Replacing ALC/RSOD with ALC/RUPS

Application Note

rev. 04/01/15

Older RSOD Unit Circuit Board

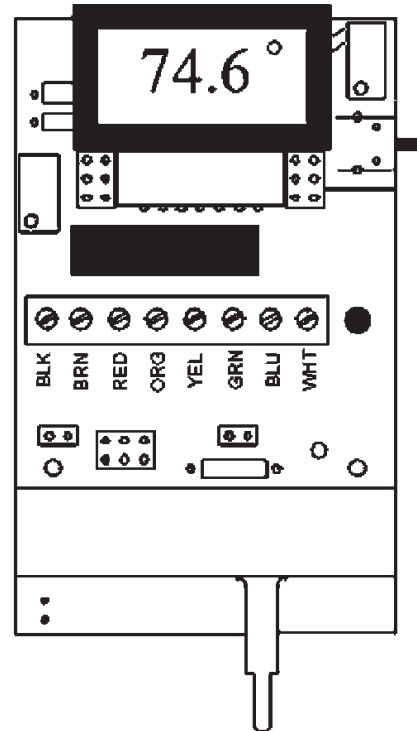
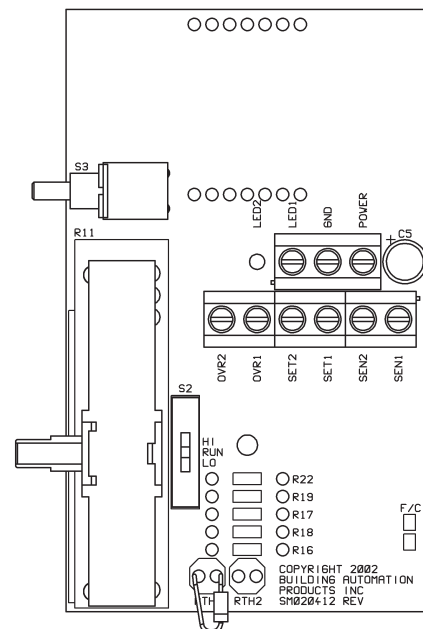
The Chart below and the images at right indicate the proper wiring terminations when replacing an older RSOD unit with the newer RμPS model:

RSOD Connection	RUPS Connection	Purpose
BLK	GND	(Ground)
BRN	SEN1	10K-2 Sensor
RED	SET1	ALC Set Point
ORG	LED1	LED On/Off
YEL	N/C	No Connection
GRN	N/C	No Connection
BLU	Power	Power
WHT	N/C	No Connection

Note: The RμPS does not require the 10K precision resistor that is located between terminals "BLU" and "BRN" on the RSOD models.
